U.S. NUCLEAR REGULATORY COMMISSION
OFFICE OF NUCLEAR REACTOR REGULATION
Division of Reactor Inspection and Safeguards

NRC Inspection Report: 50-335/91-201
50-389/91-201

Facility Name: St. Lucie Plant, Units 1 & 2

The Special Inspection Branch of the U.S. Nuclear Regulatory Commission performed a pilot team inspection, the Service Water System Operational Performance Inspection, at the St. Lucie Plant, Units 1 and 2, during the period September 23 through October 4, 1991.

Figure 1 St. Lucie 1 Intake Cooling Water System

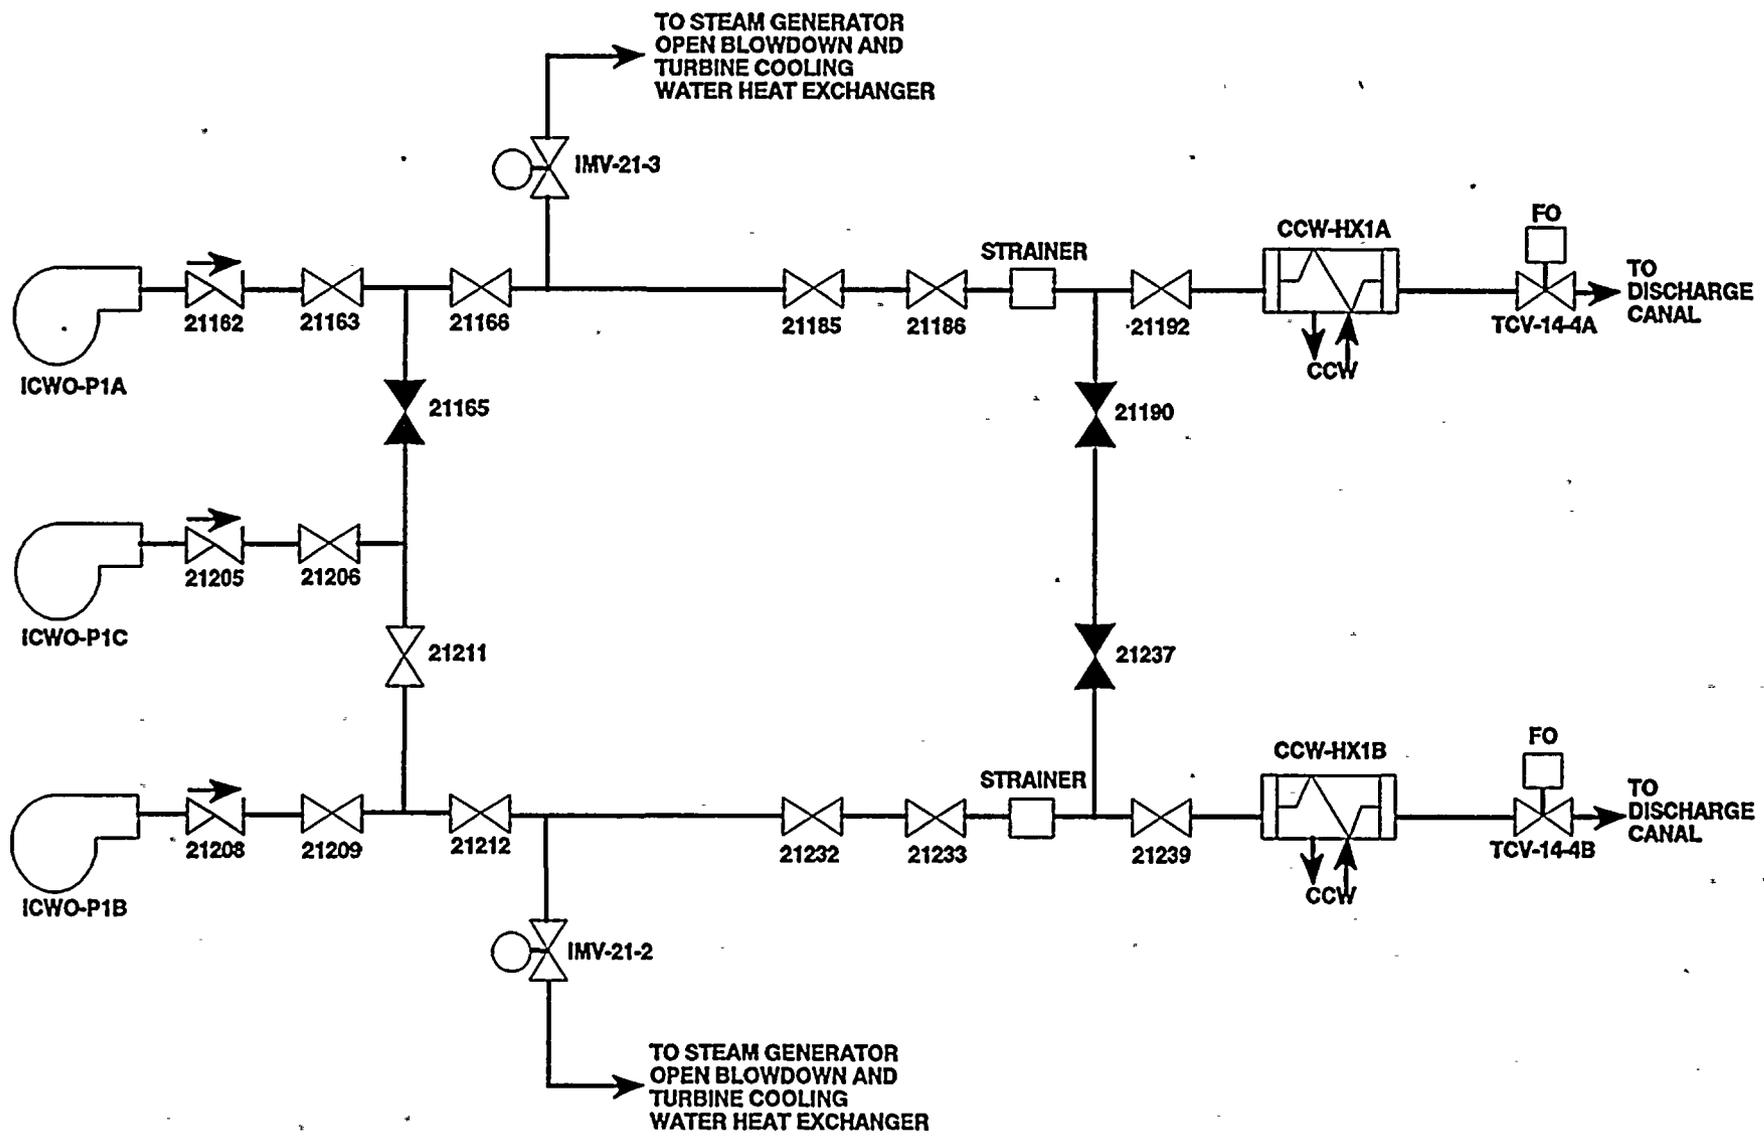
In reviewing the specific design details and configuration for the ICW system, the team identified several design weaknesses and vulnerabilities ((a) and (d) of which are mitigated by the self-lubrication modification) that could potentially compromise the ability of the ICW system to satisfy its safety function. Specifically:

- (a) The lubricating water supply to the ICW pumps was susceptible to a common-mode failure because the two trains of lube water joined in a common header. For example, certain scenarios could have prevented the flow of lube water to all ICW pumps: (1) a pipe break in the common lube water header or (2) a bearing failure on one of the ICW pumps which could have drawn excessive lubricating water and thus starved the remaining pumps. (Appendix B, Observation Number 91-201-03)

- (b) The nonessential header isolation valves (MV-21-2 and MV-21-3) were located below the flood level but were not qualified for submersible operation. Operability of the ICW system could be compromised during a flood if a pipe break occurred while the TCW system headers were cross-tied. Since TCW was not safety related, this scenario is credible given the corrosive nature of the service environment. (Appendix B, Observation Number 91-201-04)
- (c) The ICW strainers could only be bypassed manually making operation difficult during extreme bad weather.
- (d) The Unit 1 lubricating water Zurn strainers were located below the flood level making it impossible to backwash the Zurn strainers during a flood.

- (b) The TCVs did not operate as described in the Unit 1 FSAR. The FSAR indicated that these valves failed in the open position. However, the team found that TCV-14-4A and TCV-14-4B could not be opened beyond 45° (50% open). Apparently during preoperational testing, the licensee determined that it was necessary to restrict valve opening in response to hydraulic considerations, but the licensee failed to reflect this limitation in the FSAR. The open stop ensures operability of the system by preventing pump runout. The limitation is of sufficient importance that it should be noted in the FSAR to ensure that the system would function as required in its fail-safe position as addressed by Standard Review Plan (SRP) Section 9.2.1.
